HISTORIC AND DESIGN REVIEW COMMISSION

September 21, 2016

HDRC CASE NO: 2016-370
ADDRESS: 367 QUENTIN DR
LEGAL DESCRIPTION: NCB 8411 BLK 6 LOT E 25 FT OF 6 & W 35 FT OF 7
ZONING: R6 H
CITY COUNCIL DIST.: 7
DISTRICT: Monticello Park Historic District
APPLICANT: Robert Flores
OWNER: Robert Flores
TYPE OF WORK: New construction of an accessory structure
REQUEST:

The applicant is requesting a Certificate of Appropriateness for approval to construct an 18' x 25' rear shed.

SITE PLAN SCALE 1/8" TO 1'

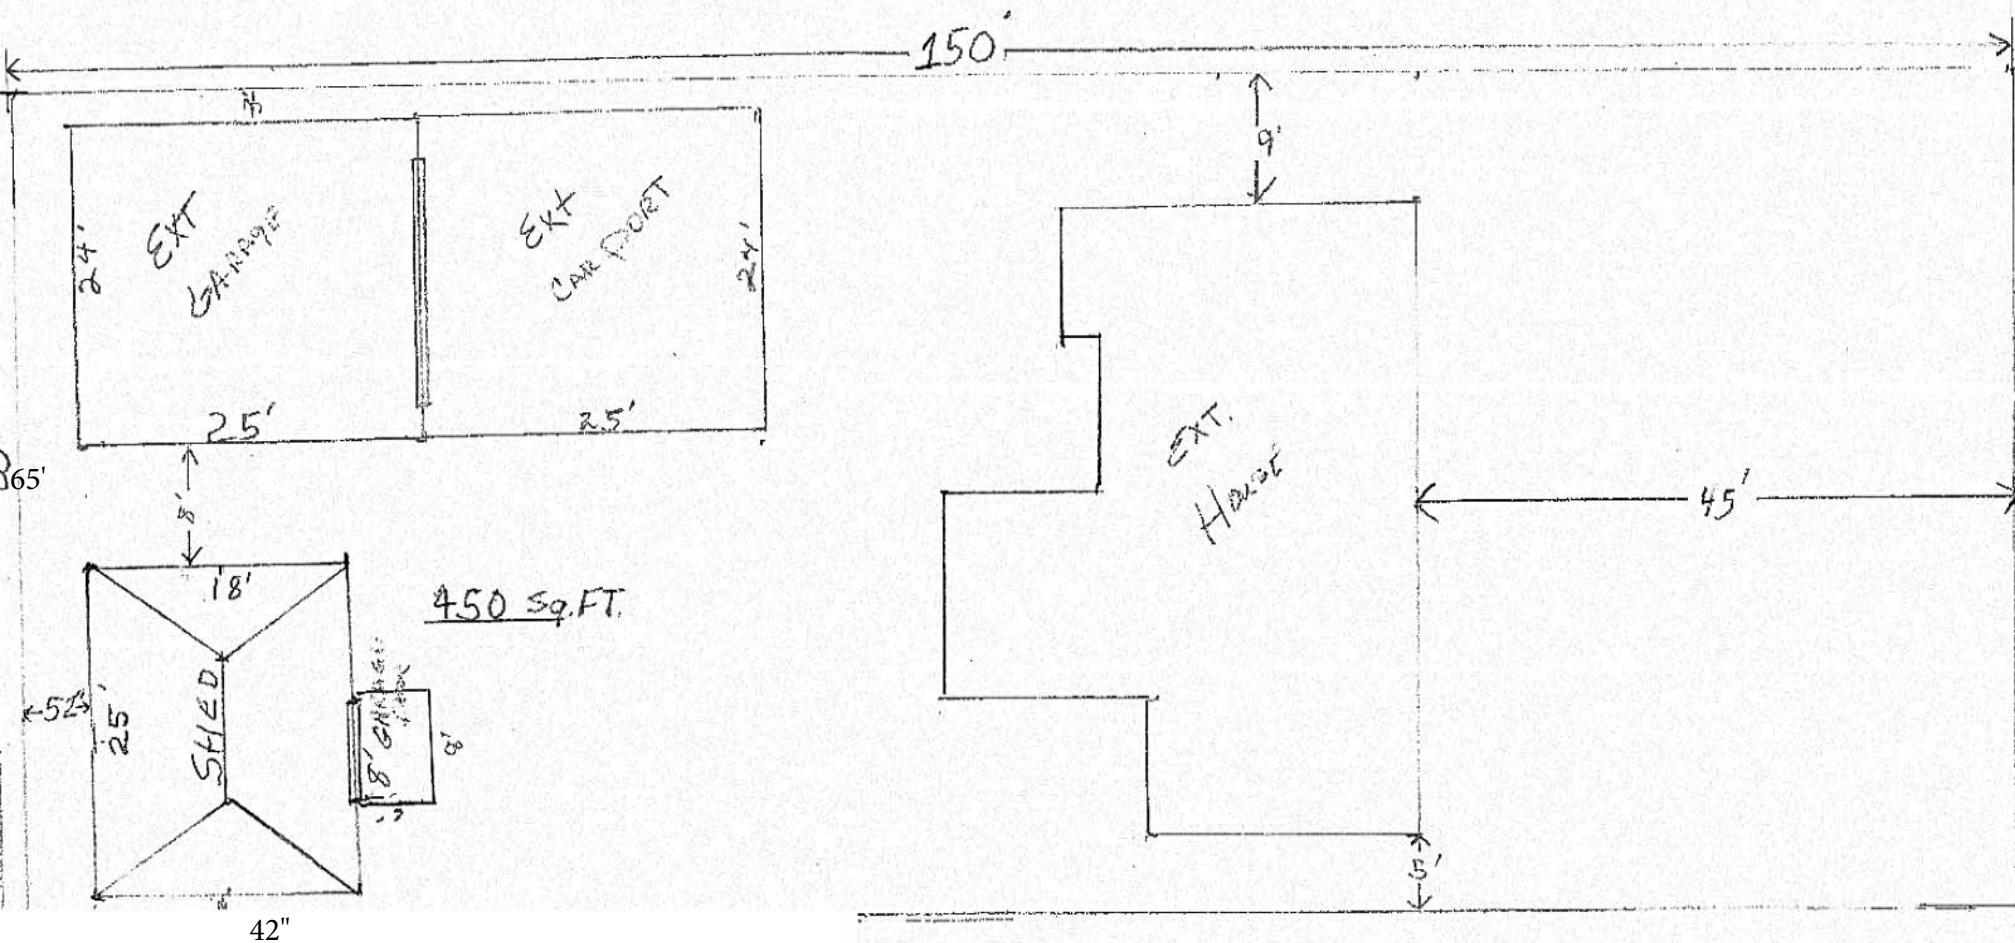
- f. SETBACKS/ORIENTATION - The proposed shed is 42" from the left property line, 52" from the rear property line and 8' from the existing garage structure, located to the rear of the main structure. According to the Guidelines for New Construction 5.B, new outbuildings match predominant garage and carport orientations. Staff made a site visit on September 12, 2016, and found the shed is not visible from the public right-of-way and that historically accessory buildings are in the rear of the main structure. Staff finds the proposed setback and orientation consistent with the Guidelines.

The applicant is responsible for meeting setback requirements set by the UDC.

FRONT ELEVATION N $\frac{1}{4}$ " SCALE

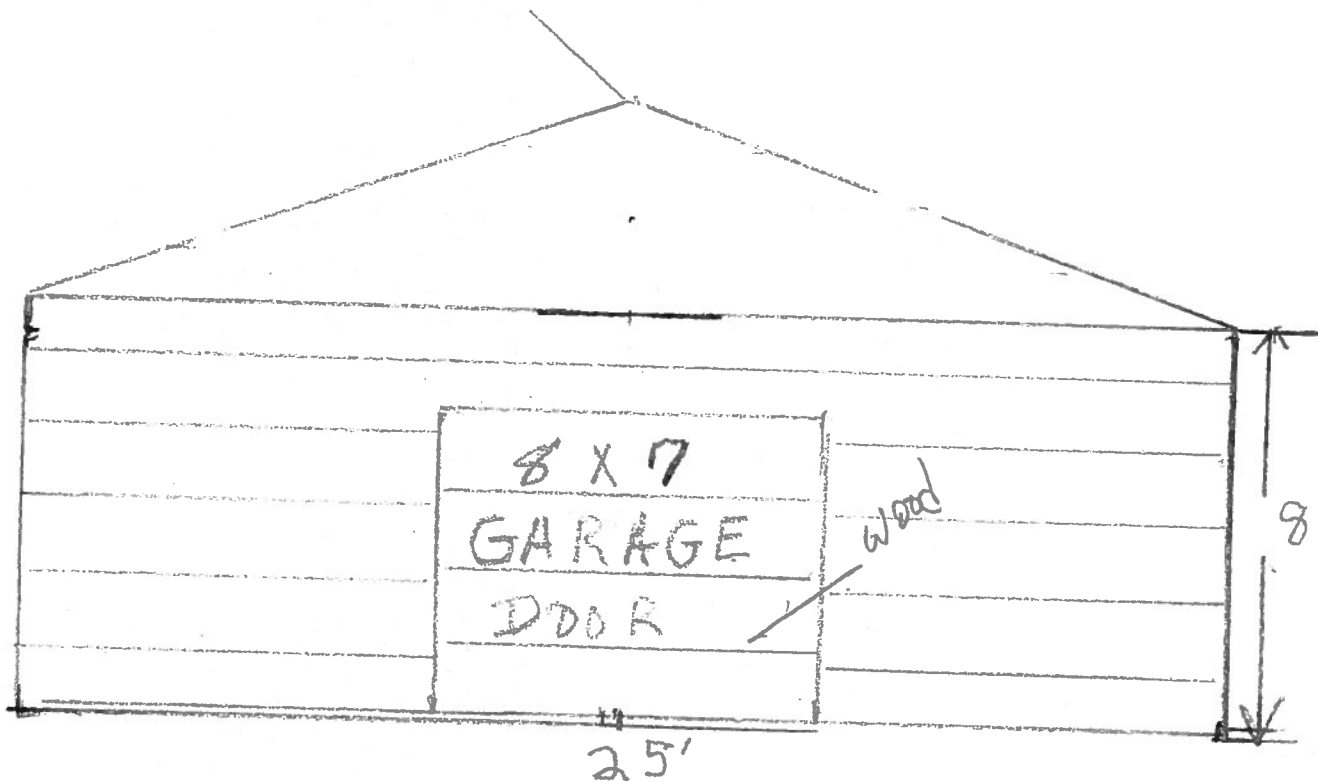
- e. DOORS – The existing framed shed has 3 pedestrian door openings. The applicant is proposing to install one wood 8' x 7' garage door. According to the Guidelines for New Construction 5.A.v., door should be similar in proportion and materials as those traditional found in the district. Staff finds the proposal consistent with the Guidelines.

- 1. That the applicant submit garage door details to staff prior to receiving a Certificate of Appropriateness.
- 2. That the applicant submit siding profile details to staff prior to receiving a Certificate of Appropriateness
- 3. That the shed eaves match those of the existing garage.
